# Response to Representations – St Lukes DA 0486/2021

89-93 CIMITIERE STREET

SUN STUDY COMPARISON

ST. LUKES HEALTH

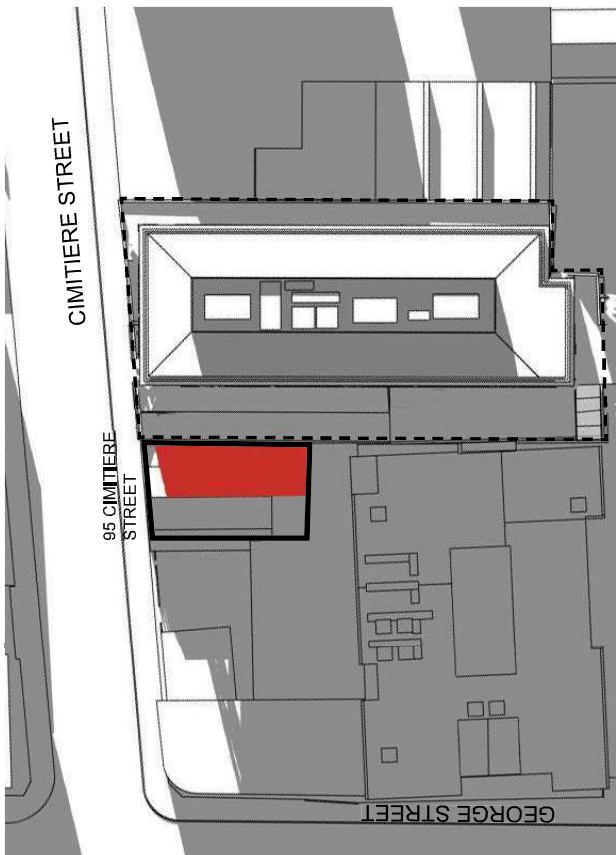
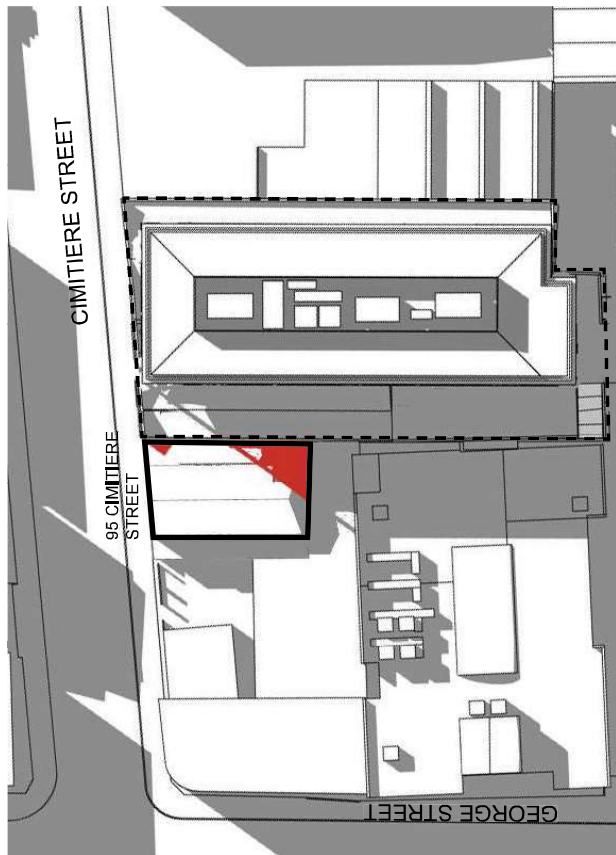
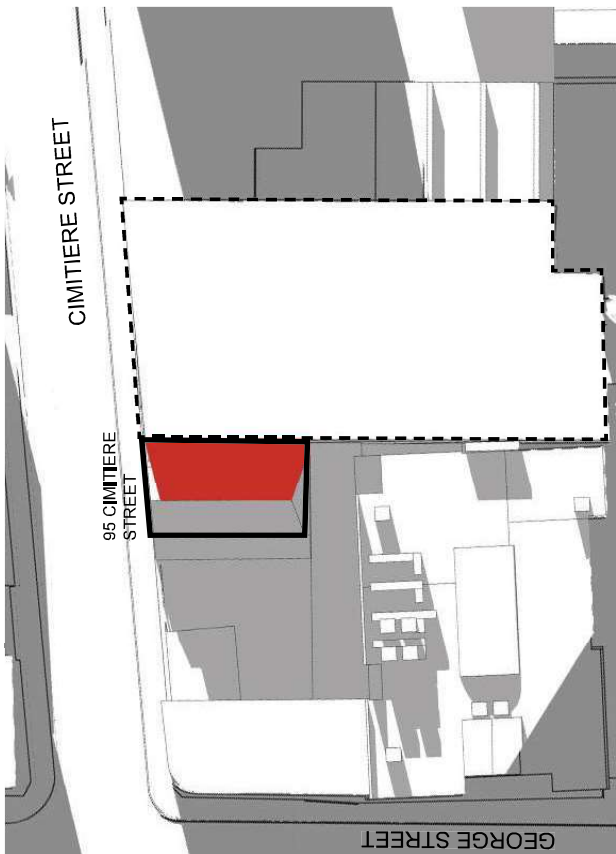
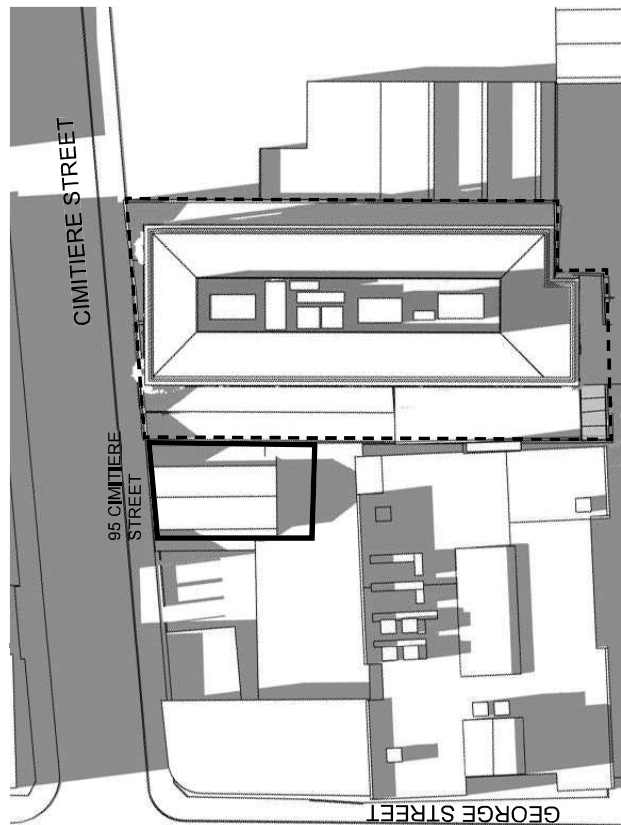
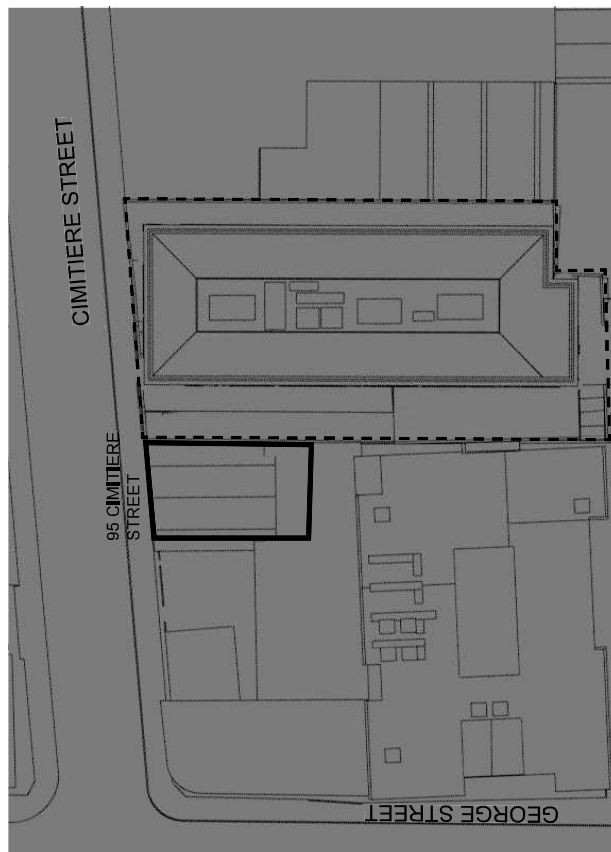
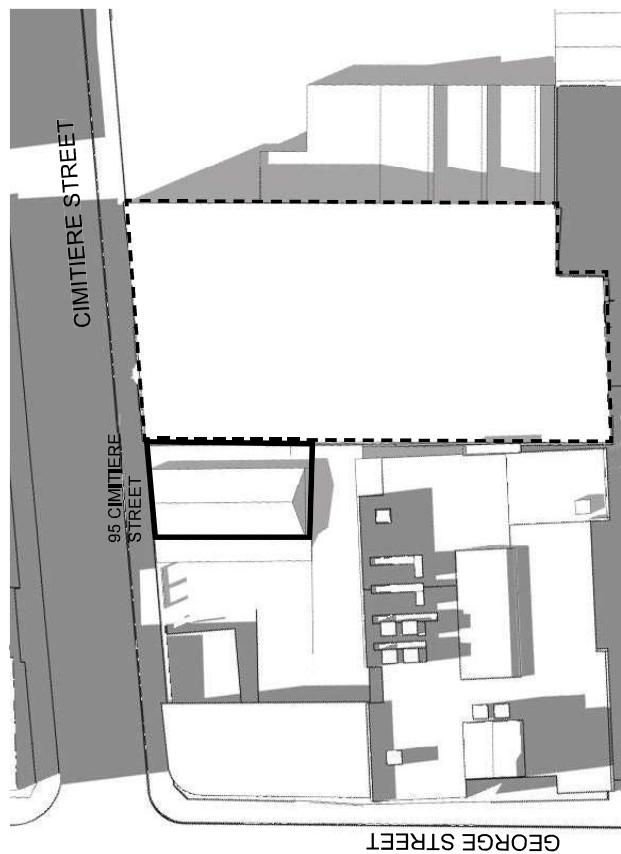
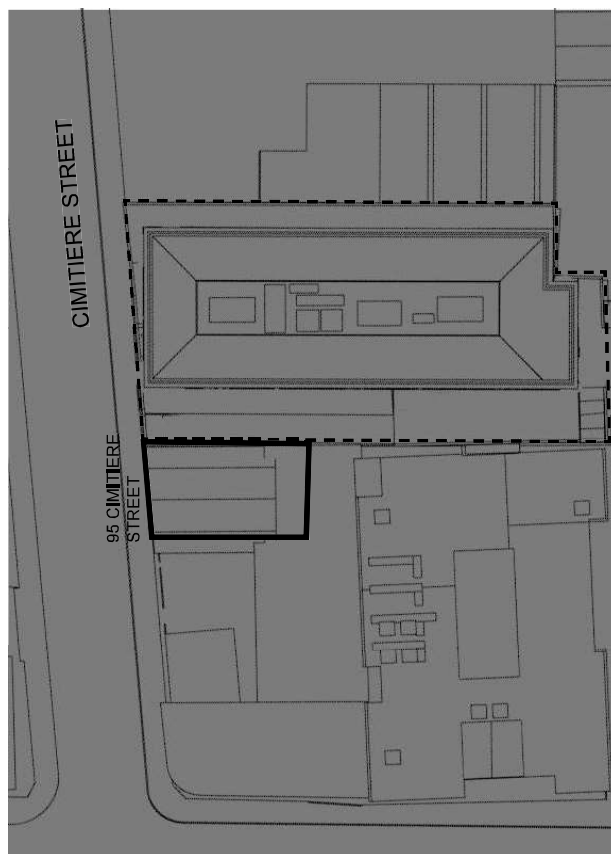
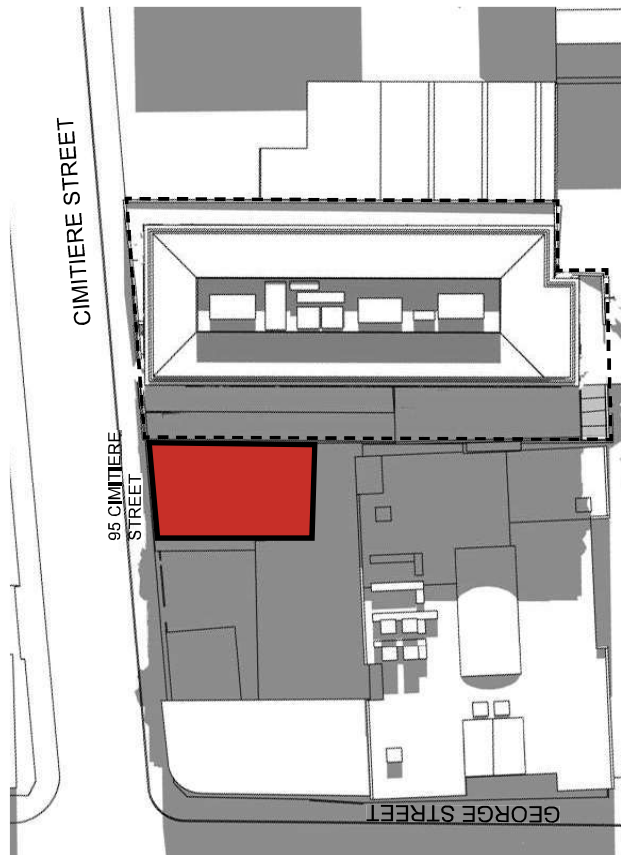
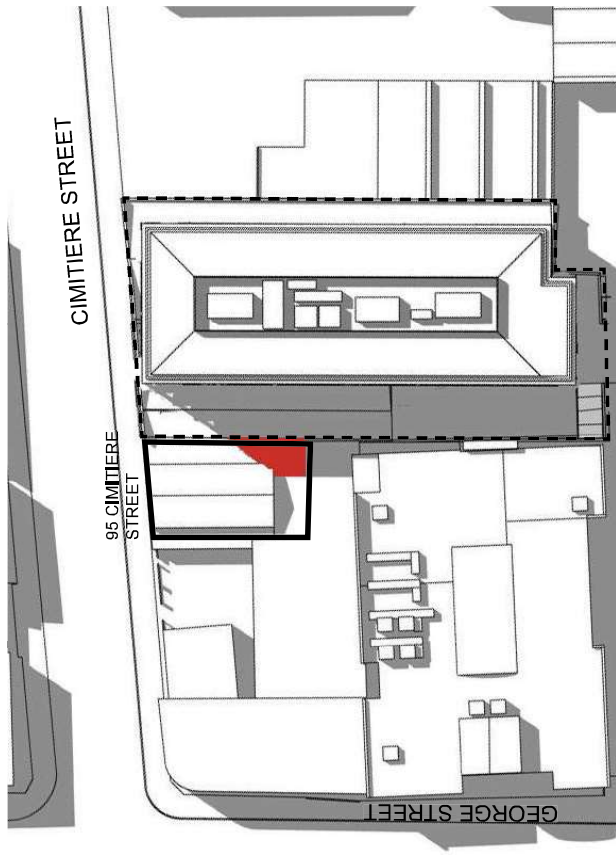
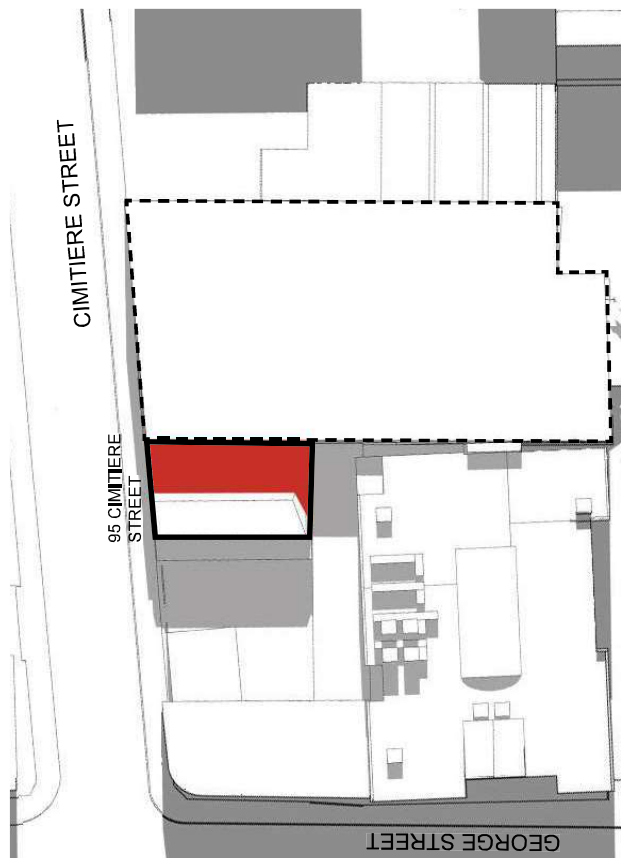
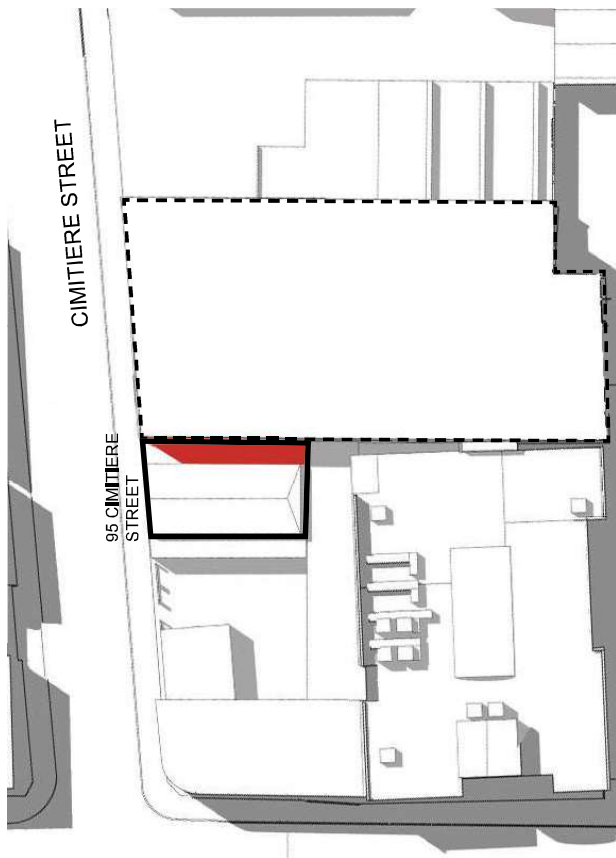
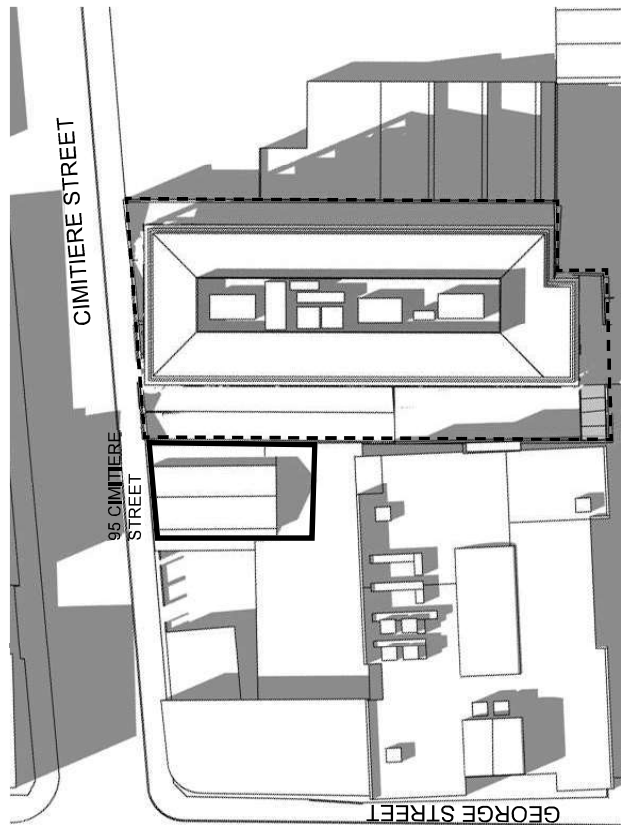
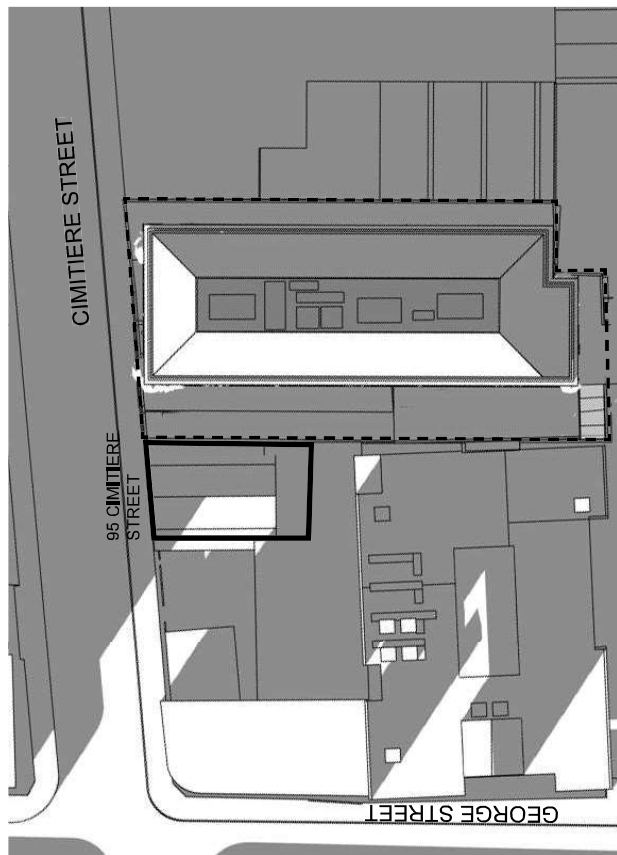
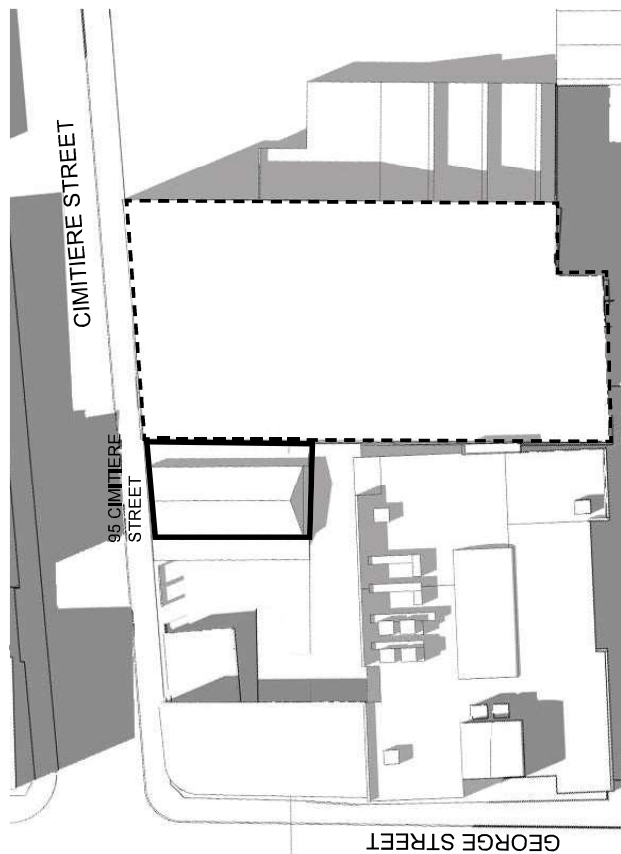
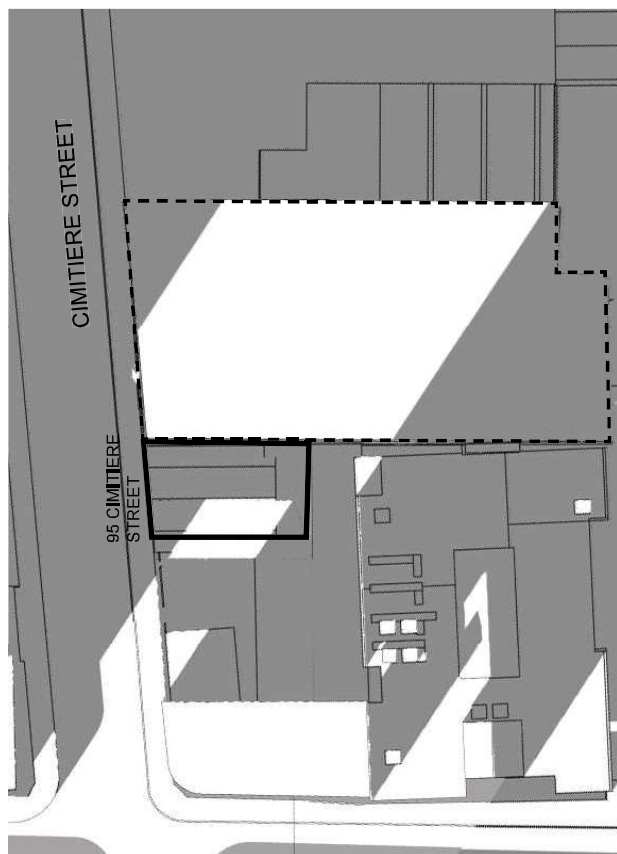
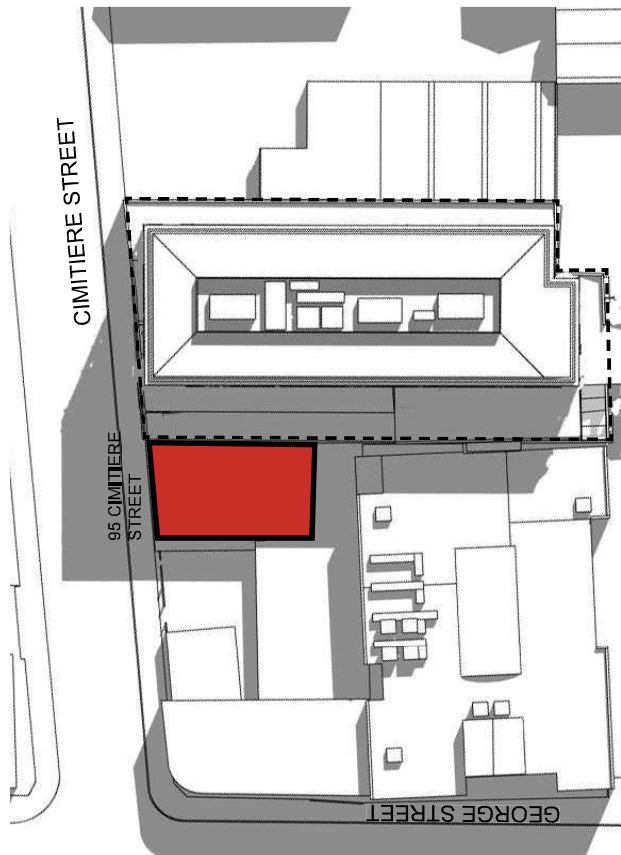
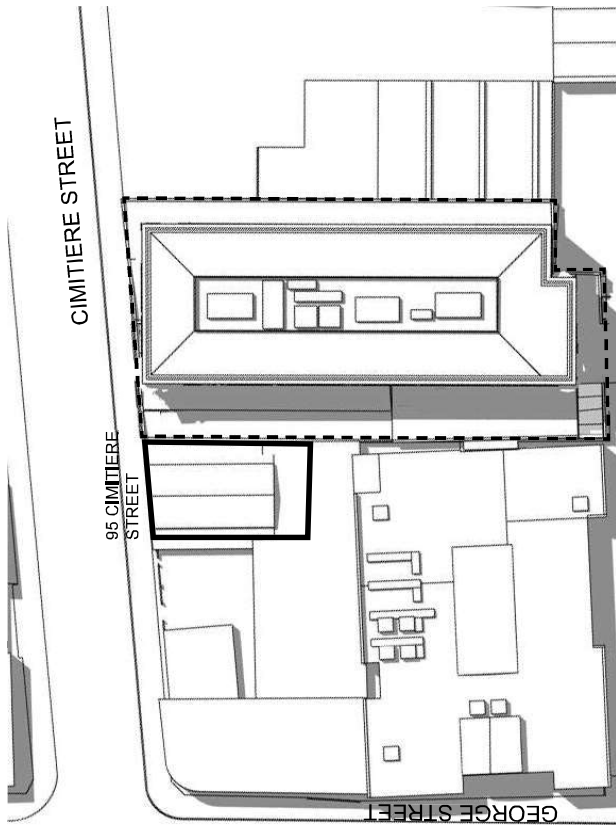
| <p>Representor owns adjoining property to the west. Concerned that the proposed building height will render the representors solar panel installation virtually useless during most of the day</p> | <p>considered for its value in shading the upper two level's facades and providing a visually attractive roof garden to Level 6.</p> <p>Additional shadow studies (copy attached) have been provided for 21st June, 21<sup>st</sup> September and 21<sup>st</sup> December to compare the proposed building and a building constructed to the permitted building envelope under the zone i.e 12m high and built to the side boundaries.. The sun studies show that the overshadowing is equal and, at times, is reduced to that of a permitted height building due to the set back of the west elevation. An increased shadowing of the proposed building to the permitted building only occurs at 9am between September and December.</p> |

| <p>Representor has plans to construct an upper level apartment on their building. The amenity and lack of privacy of this future apartment will be impacted by the proposed building.</p>          | <p>As per comments above, the orientation of the building to the street means solar access is maintained to adjacent properties for morning or afternoon periods.</p>  |
